**Revisiting CX4 Transition Time Definition  
and Measurement  
Ze'ev Roth**

# Results

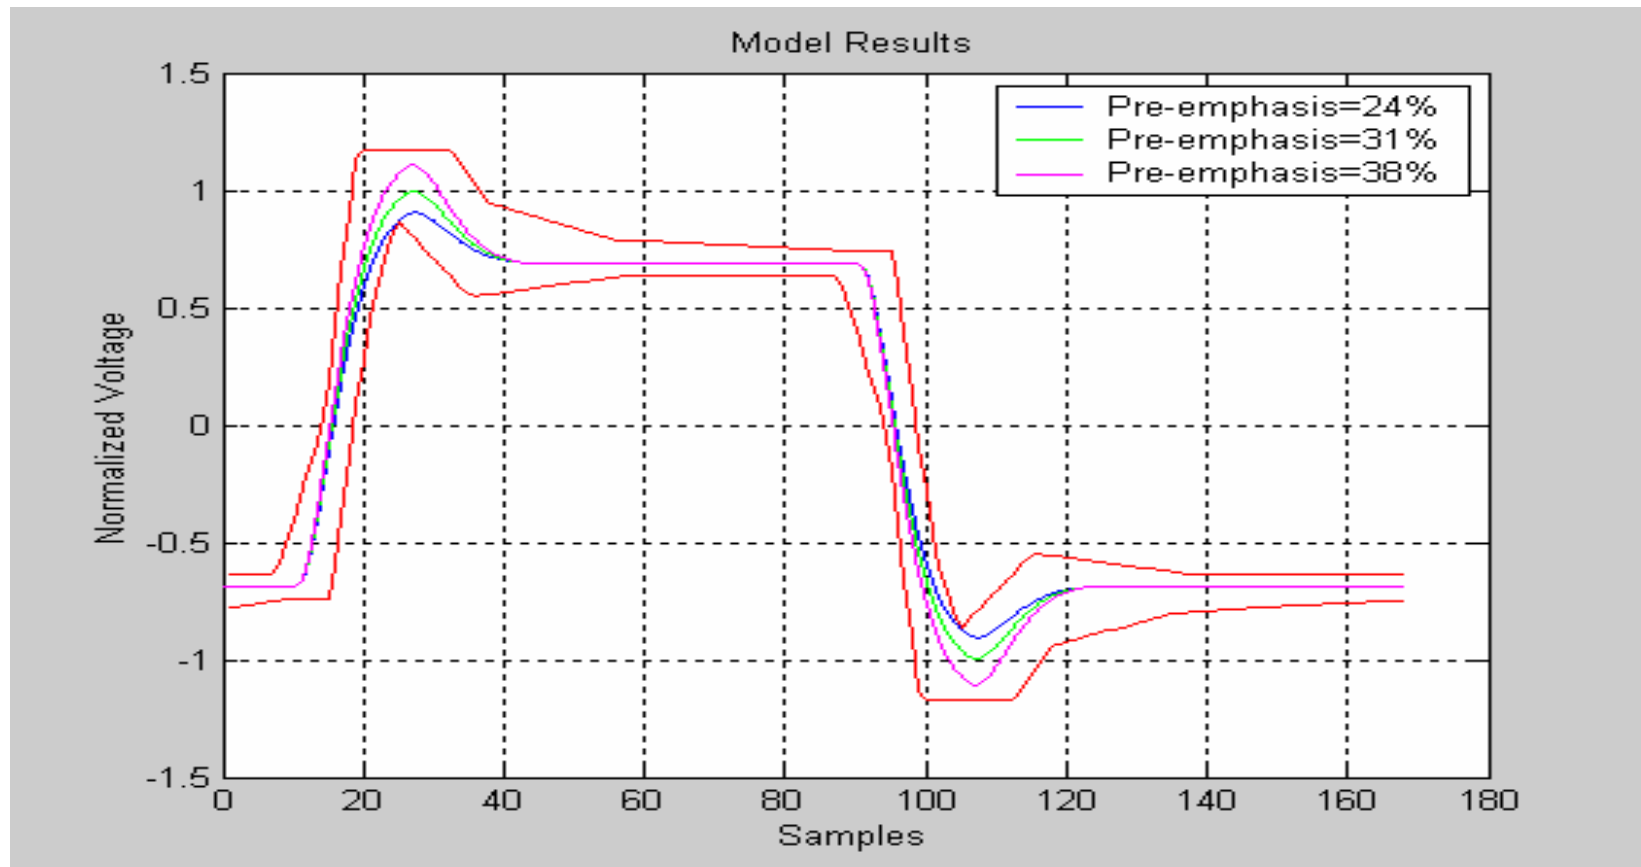
- By nominal rise we refer to the transition time as measured according to 20%-80% of the transition swing
  - Note that normalization process does not change the 20%-80% transition times

- All three templates are within the limits

- Pre-emphasis effects the rise time measurement
- About 10% difference from nominal value at low and high pre-emphasis values
- Problematic cases are shaded

- Current CX4 definition causes unnecessary coupling between rise/fall time and pre-emphasis.
- Propose to revert to 20%-80% rise time definition
  - Basic idea is that for the normalized template we know that the starting point of the positive transition is at normalized voltage level of -0.69 to define the 20%-80% thresholds all that remains is to find the peak
  - Similarly for negative transition the starting point is 0.69
